Access Compliance Report

Public Rights-of-Way

| Intersection ID: 45860 | Main Street: FRYE_PL | Cross Street: HENDERSON_OAKS_DR | Location: W |
| ADA ID: 597A6D69FABD | Ramp Type: Perp | Initial Pass/Fail: Pass | Overall Compliance: No |

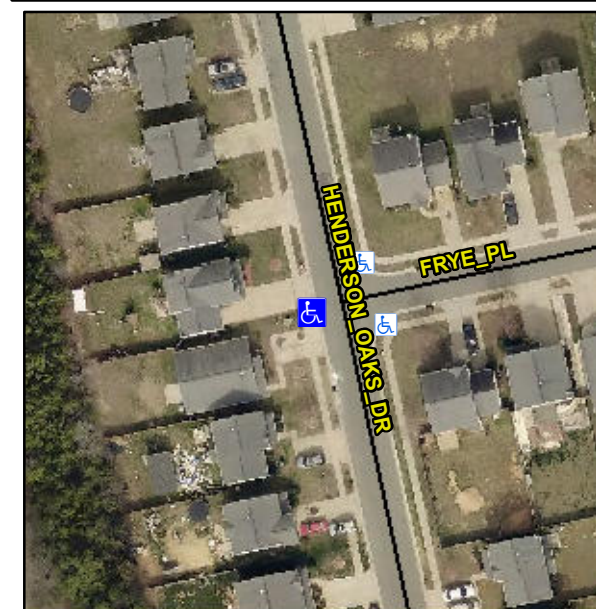
| Compliance | Description | Data | Compliance | Description | Data |
|------------|-----------------------|--------|------------|-----------------------------|------|
| Yes | Landing Length (in) | 48.0 | No | DWS Provided? | No |

Possible Solutions:

Install Detectable Warning System.

R305
